Addendum # G-1

Project: Adaptive Reuse: Craven County Jail to Emergency Operations Center
Phase 1 - Demolition

Owner: Craven County
Address: Craven Street
City: New Bern, NC

2 Level 2 - Demolition
1/8" = 1'-0"

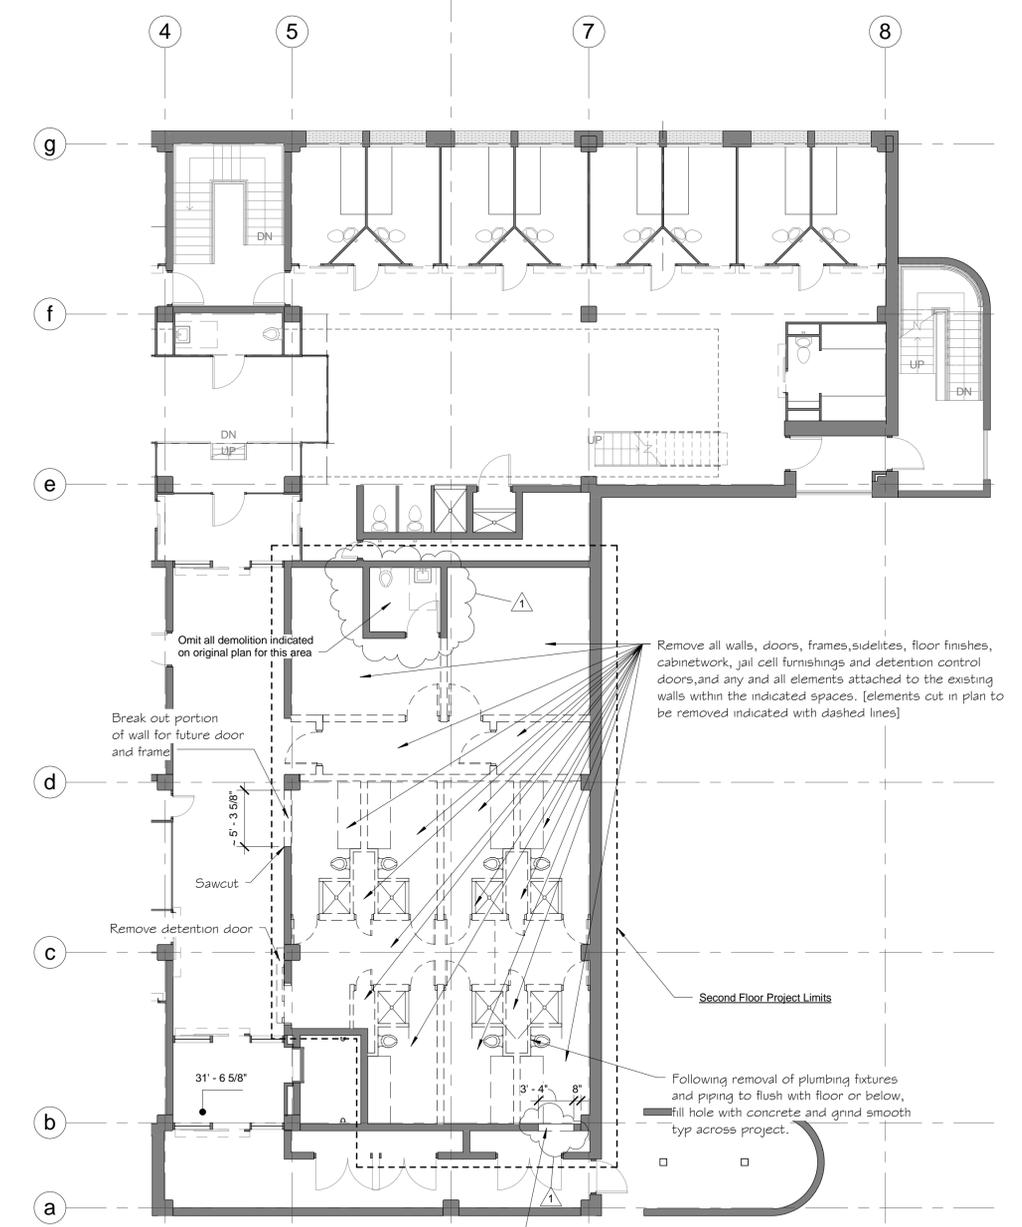
- [1] Sheet a1.1 Level 2 – Demolition [plan]
Omit demolition of existing toilet.
- [2] Sheet a1.1 Level 2 – Demolition [plan]
Add the demolition of a portion of a CMU wall for the future installation of a new door and frame. Demolition includes the installation of a new bond beam lintel with the bottom of the lintel at 7'-4" AFF.
- [3] Sheet a1.1 Level 1 – Demolition [plan]
3 areas are indicated as locations for the placement of debris disposal equipment and devices. Windows may be removed in two of these areas. Caution fencing will be required to segregate two of the areas from the public.
- [4] Sheet a1.3 Wall Section
Modify the design of the new wall as indicated.
